Biofidelity Tests for WorldSID 5th Female

GRSP Informal Meeting
February 4, 2010

ISO TR 9790 – Thorax Test 2

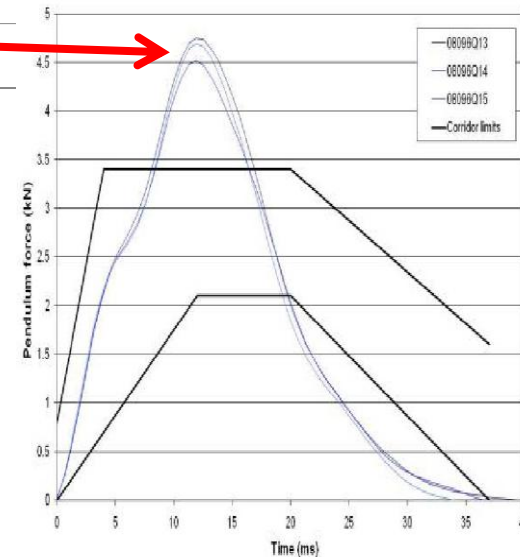
- Tests Conducted:
 - Dummy Seated Upright as Specified by TR9790
 - Dummy Seated on WorldSID Bench
- Only Use Results from Dummy Seated Upright for ISO Biofidelity Assessment
- Same applies to 4.3 m/s
